# ENGINEERING NOTICE

**Area Affected:** Analog Gauge Mercury V8 Installations

**Quality Issue:** Trim is not displaying properly on analog gauges.

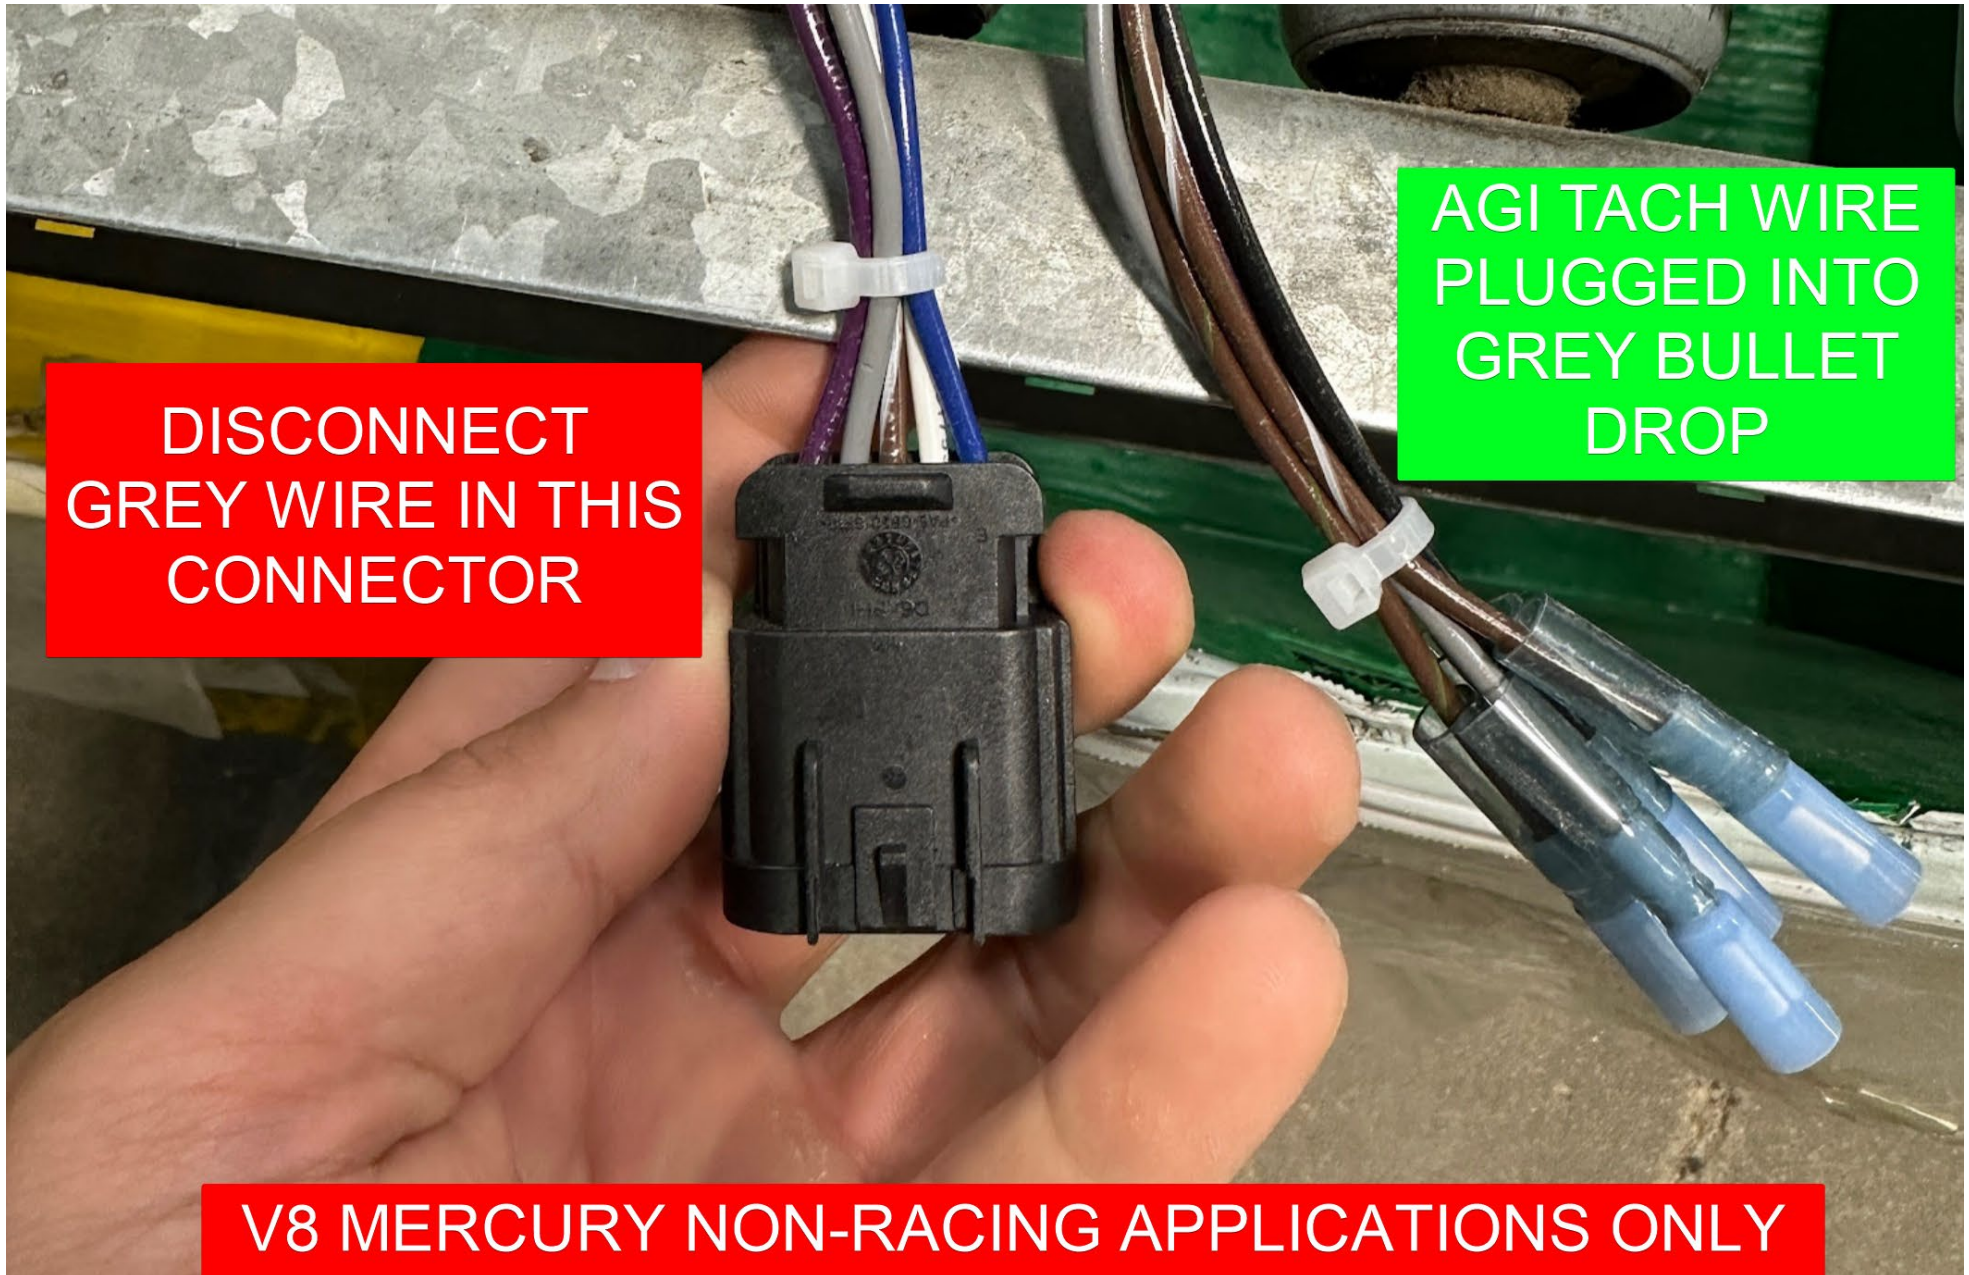
**Concern / Escape Description:** Boats with analog gauges, a Mercury V8 Outboard utilizing the AGI harness tach wire have an extra tach wire hooked up under the dash that is causing interference on the tach reading.

DISCONNECT  
GREY WIRE IN THIS  
CONNECTOR

AGI TACH WIRE  
PLUGGED INTO  
GREY BULLET  
DROP

V8 MERCURY NON-RACING APPLICATIONS ONLY

**Fix:** Locate the Mercury connector found on the dash harness (found either plugged into the Mercury main harness or Mercury Junction Box) and disconnect the Grey tach wire. Ensure gauge is set to Mercury 150+. Please see page 2 for reference.
